NS9775B-0

Errata

90000527, Rev E

NS9775 Hardware Reference, Rev. C

UART gap timer

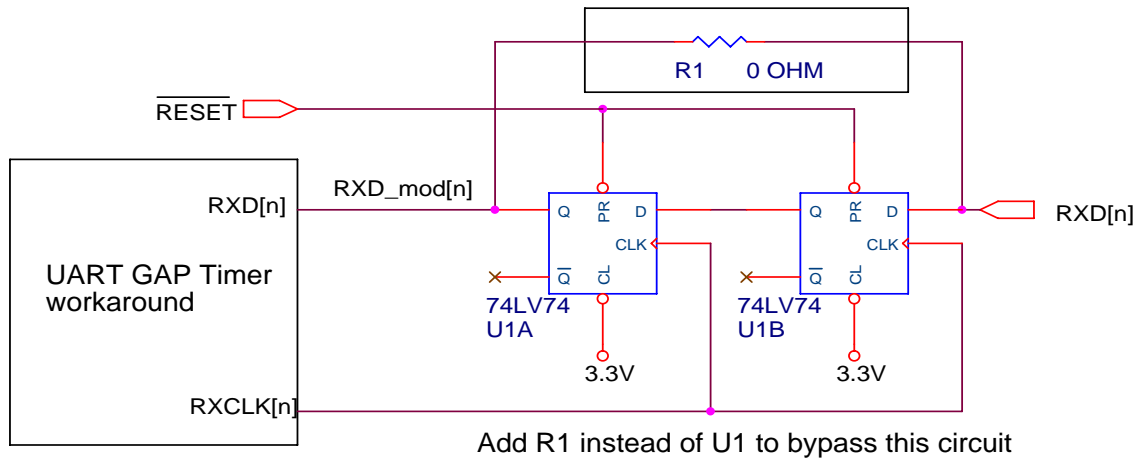
The start bit of a new character may not be detected when the character or buffer gap timer expires. Framing, parity, or data corruption occur when a start bit is missed.

A hardware workaround eliminates the possibility of receiving a start bit when a character or buffer gap timer is expiring. The workaround drives the baud clock off-chip and synchronizes the incoming data with this clock. As a result, the buffer and character gap timers and the next start bit have a fixed and known relationship with each other.

Hardware workaround:

Note: The hardware workaround requires that you have installed the appropriate software patch found in the NETOS SW Toolkit (on the Web).

- The TMODE bit in the Bit-rate register must be cleared.
- Baud rates are limited to those available in x16 mode
- Baud rates with a divisor of 0 are not possible for all CPU frequencies. This translates to a maximum baud rate of 460k in x16 mode.
- Baud rates with a divisor of 1 are not possible for CPU frequencies below 147MHz. This translates to a baud rate of 230k in x16 mode.
- The buffer and character gaps must be an even multiple of the sample clock period. For a 96000bps UART in x16 UART mode, the equation is:
- $\text{Timer increment} = ((1/9600) / 16) \times 2 = 13.020\mu\text{s}$
- One GPIO per UART is required to output the baud clock. The baud clock can be output on the RI pin on each UART. This function is controlled by the RXEXT bit (27) in each Serial Bit-rate register.

UART CTS-related transmit data errors

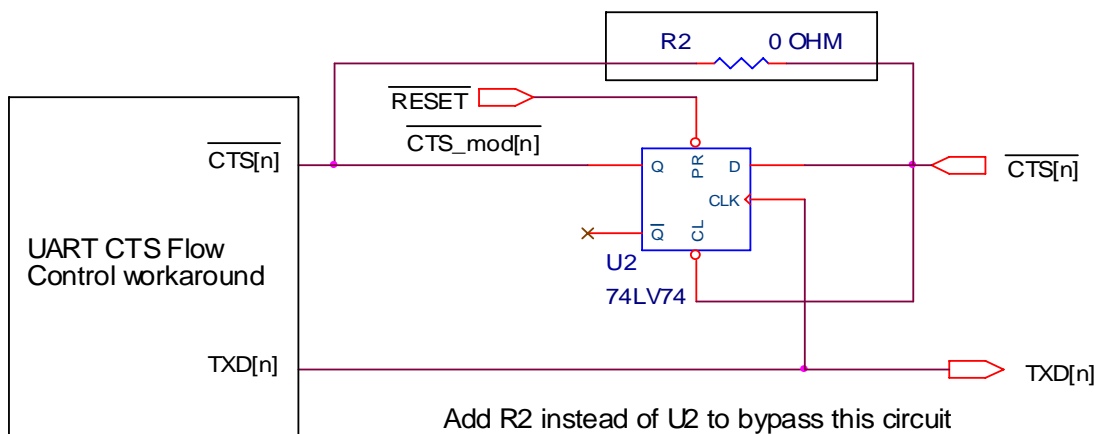
A problem occurs when the CTS flow control signal is de-asserted during the BCLK that begins processing a new character. This problem causes the previous character to be re-transmitted instead of getting the next character from the transmit FIFO.

Hardware workaround: For each UART, externally clock the CTS signal with the Txd_n signal to guarantee that CTS will not be seen de-asserting at the start of a character.

USB OVR and USB PWR

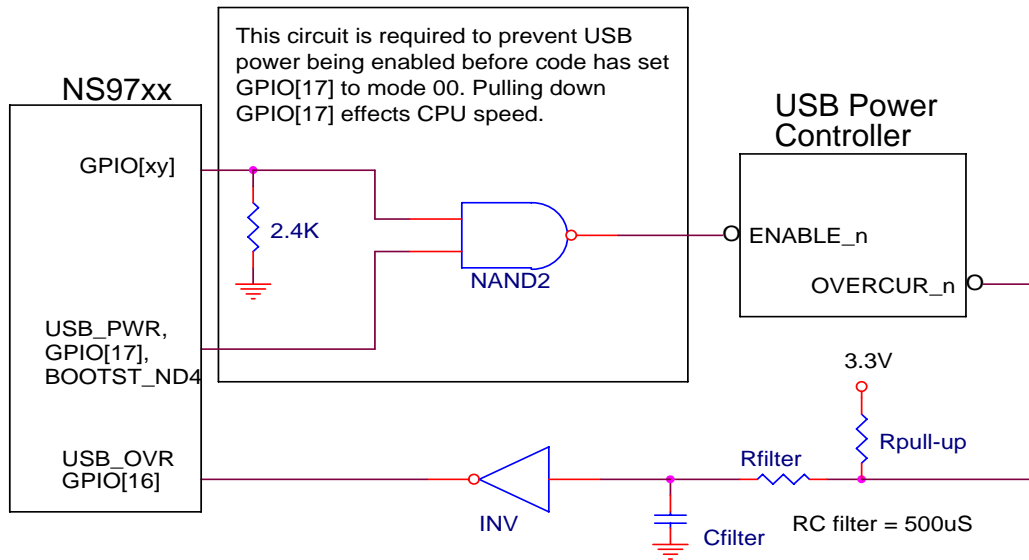
The USB PWR (power) control output requires additional external logic and GPIO to prevent USB power from being enabled from the time power is valid until the code has set the USB registers and selected gpio[17] to mode 00. The polarity of USB PWR is true high. Pulling down GPIO[17] to disable the USB power control changes the CPU bus speed because this pin is also bootstrap – ND4.

Designs that add the additional GPIO to prevent USB power-on during startup would require the BSP, as a final step, to set this GPIO to output a 1.

This drawing shows a recommended logic workaround:
